CALIFORNIA COASTAL COMMISSION

STAFF REPORT: REGULAR CALENDAR

APPLICATION NO.: 4-09-013

PROJECT DESCRIPTION: Follow-up to Emergency Coastal Development Permit No. 4-98-024-G for placement of rock rip-rap revetment along an approximately 500 foot long section of the west bank of lower Malibu Creek. The proposed project also includes revegetation of the revetment site to create approximately 0.59 acres of riparian and upland habitat.

Exhibit 6
4-09-013 (Mariposa)
Surveyed Site Plan with Cross Sections

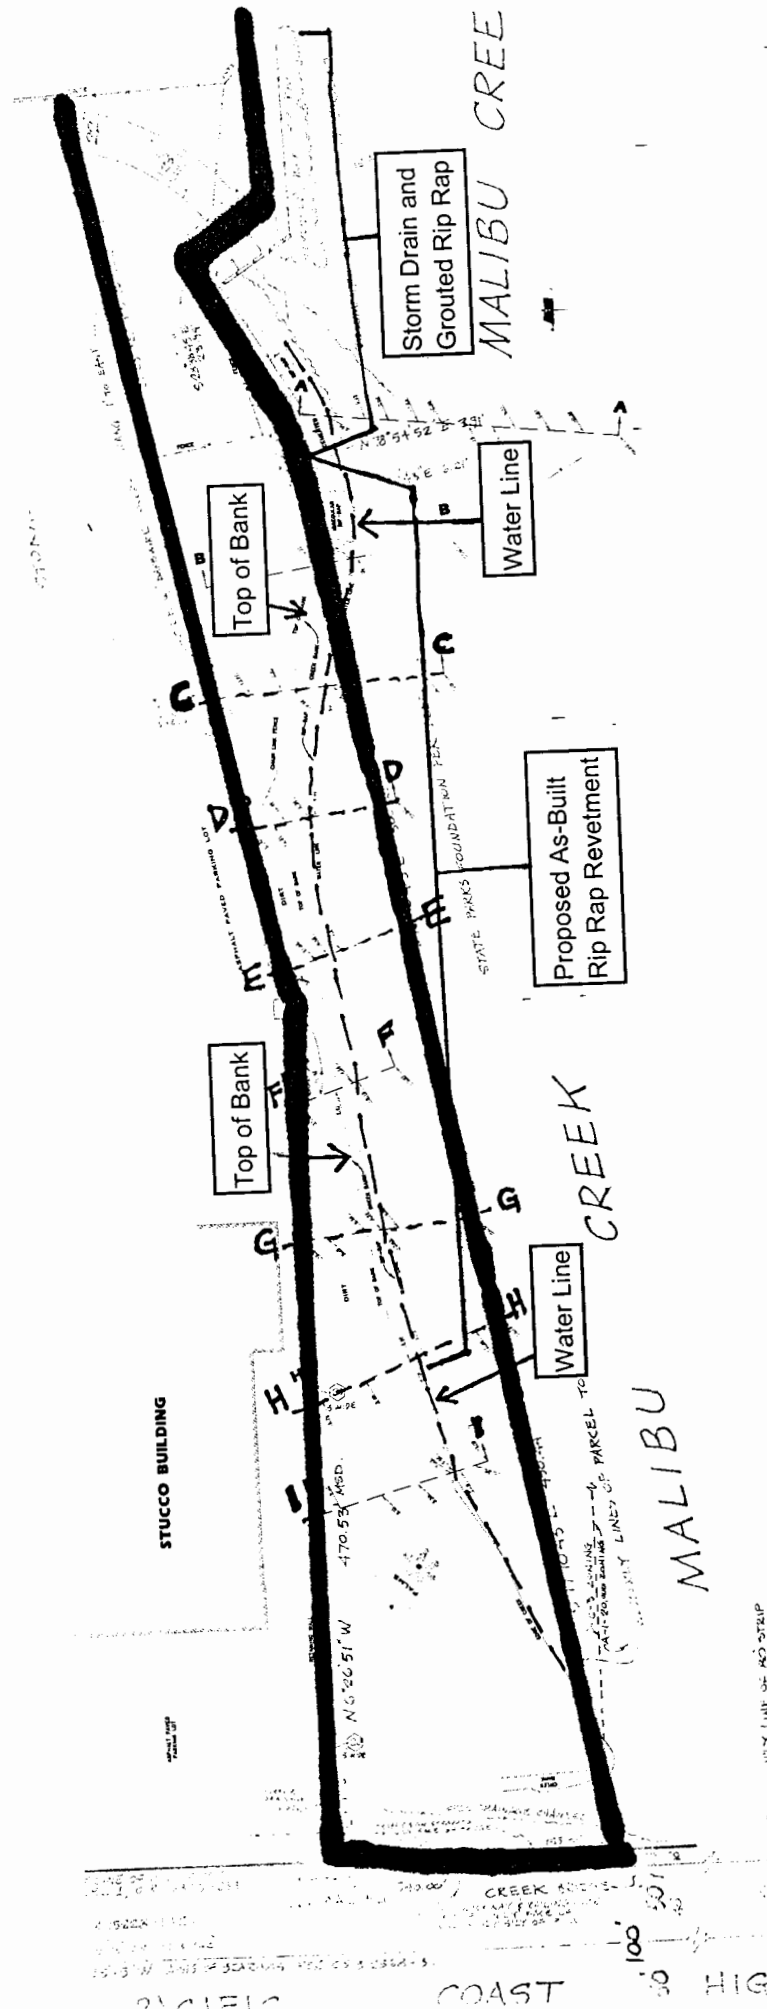
1. That the rock slope protection has been re-engineered to be laid back to a 3:1 (H:V) slope for all on-site areas where it is feasible; however, the re-engineered slope shall be no steeper than 2:1 (H:V) in any location. Where a 3:1 slope is determined to be infeasible by a registered engineer for any portion of the revetment, the applicant shall provide evidence, for the review and approval of the Executive Director, demonstrating that a 3:1 slope is either hydraulically infeasible or spatially infeasible given site characteristics. The rock slope protection shall be designed to an appropriate depth to minimize undercutting of the revetment and integrated with the adjacent existing grouted rock slope protection to the north and the natural bank to the south.

Application No. 4-98-024 was filed on May 21, 2008, and would have had to have been acted on by the Commission at its November 2008 meeting in order to comply with the Permit Streamlining Act (PSA). However, in order to allow staff adequate time to analyze the recently submitted surveyed as-built plans, the applicant extended the Commission's review time by 90 days. The application was then scheduled for the February 4, 2009 Commission hearing and a staff report was circulated on January 22, 2009. The February hearing was the last hearing the Commission could act upon the application before the 270th day PSA deadline. Therefore, since the applicant found they needed more time to respond to the January 22, 2009 staff report, the applicant withdrew permit application No. 4-98-024 two days before the scheduled hearing and re-submitted it as a new application. The re-submitted application is identical to the previous application, but it was assigned a new permit number (4-09-013) and filed on February 2, 2009. This application was brought to a Coastal Commission hearing on April 9, 2009. At the meeting, the Commission continued this item and directed staff to provide additional analysis regarding the revegetation-only alternative, and the feasibility of laying the recommended vegetated rip rap design alternative back to a 3:1 (H:V) slope where possible.

Prior to issuance of the Coastal Development Permit, the applicant shall submit, for the review and approval of the Executive Director, two (2) sets of revised rock slope protection/grading plans with representative cross-sections. The plans shall be prepared and stamped by a registered engineer. The revised plans shall demonstrate the following:

Exhibit 7
4-09-013 (Mariposa)
Proposed Planting Plan

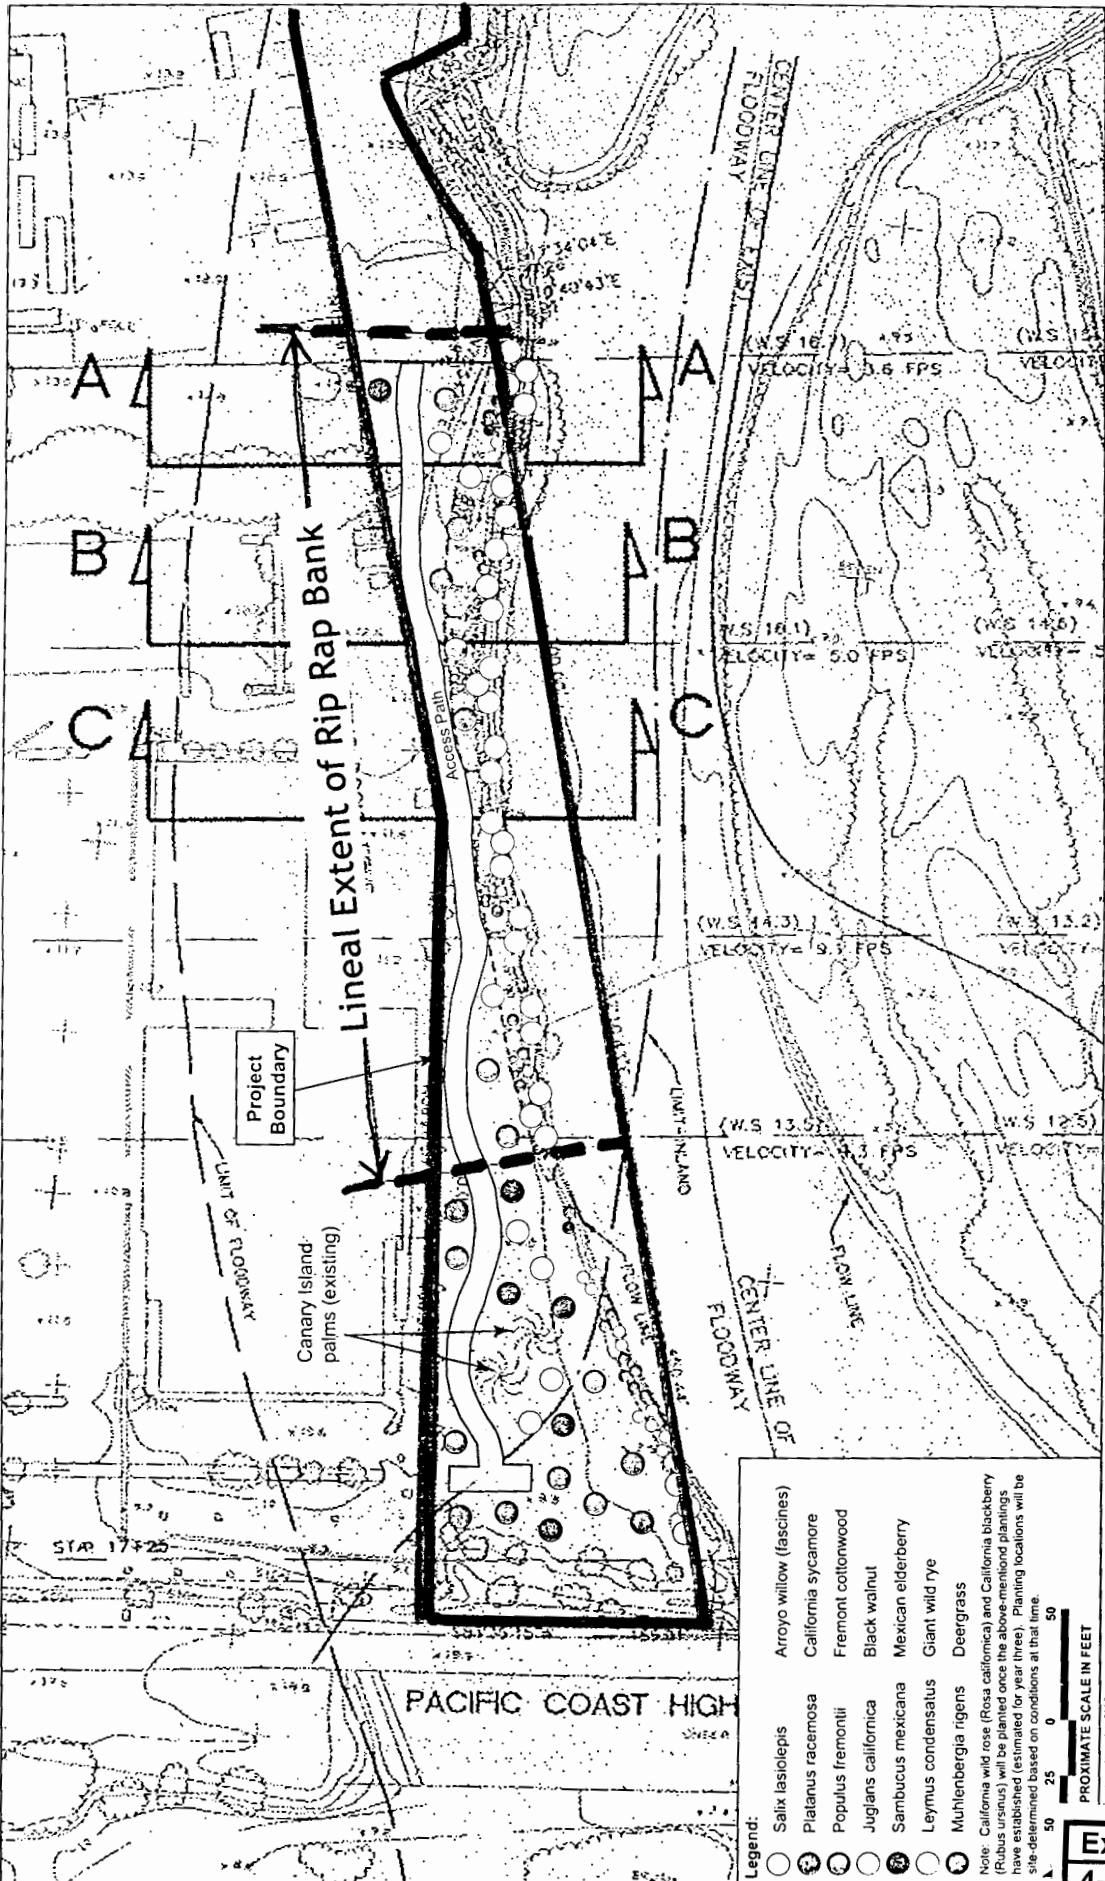
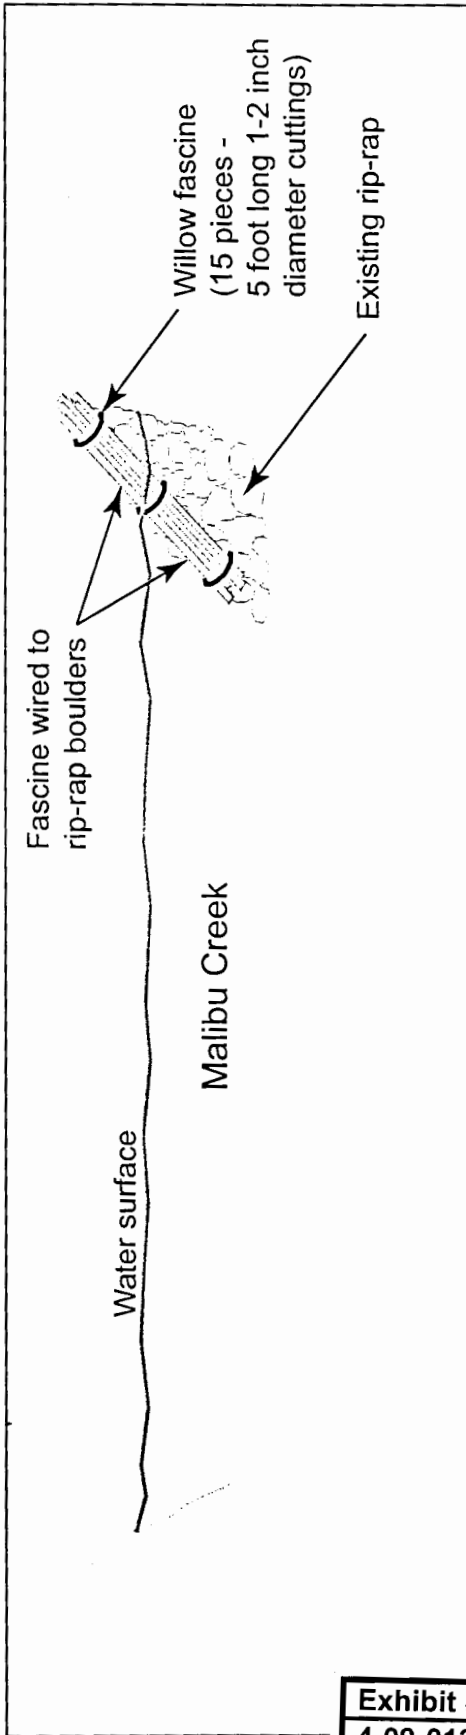
1. The "Vegetation Restoration Plan" (by Impact Sciences Inc., dated 8/2007 and amended 1/2009) shall be revised pursuant to the approved rock slope protection plan required by **Special Condition 2** above. The revised plan shall indicate that geotextile filter fabric with holes for willow plantings will be placed on the graded slope of the bank prior to rock placement to stabilize the soil. As the rock revetment is being installed, live willow stakes shall be inserted among the voids, making sure the stakes penetrate the fabric filter and underlying soil. Interstitial spaces in the rip rap shall be partially filled with a fine gravel, sand, and soil combination. In addition, alkali bulrush (*Scirpus maritimus*), yerba mansa (*Anemopsis californica*), creeping wild rye (*Leymus triticoides*), and mugwort (*Artemisia douglasiana*) shall be added to the plant palatte for revegetation of the revetment. Arroyo willow shall be planted throughout the rock slope; alkali bulrush and yerba mansa shall be planted in the frequently flooded zone; and creeping wild rye and mugwort shall be planted above the frequently flooded zone. For the portion of the creek bank that is south of the rock revetment, mugwort (*Artemisia douglasiana*), mulefat (*Baccharis salicifolia*), and California wild rose (*Rosa californica*) shall be added to the proposed restoration plant palatte.

In a letter dated January 9, 2009, Impact Sciences Inc. revised the proposed Vegetation Restoration Plan to omit the willow fascine element and to instead place willow cuttings that are at least one inch in diameter and six feet long into the interstitial spaces between rocks (**Exhibit 9**). Once the willows establish, the interstitial spaces would be filled with sand and fine gravel as a substrate for additional plantings. In researching examples where the concept of securing willow fascines to rock had been used successfully per the request of Commission staff, Impact Sciences found that willow fascines were not appropriate for use atop a rock slope protection and that the willows needed contact with moist soil beneath the rock. After consulting with the Natural Resources Conservation Service, Impact Sciences revised their revegetation plan to instead place willow cuttings into the spaces of the rip rap.

Therefore, we propose to modify the plan by eliminating the willow fascines, replacing them with willow cuttings, placed into the interstitial spaces

riprap, and into the soil where the soils is sufficiently moist on a permanent basis. Willow cuttings, which shall be at least one inch in diameter and six feet long, shall be planted at an average of one cutting per eight linear feet (63 - 65 cuttings), with some areas planted more closely than other areas to give a more natural appearance. The exact location of each willow cutting shall be determined by the project biologist.
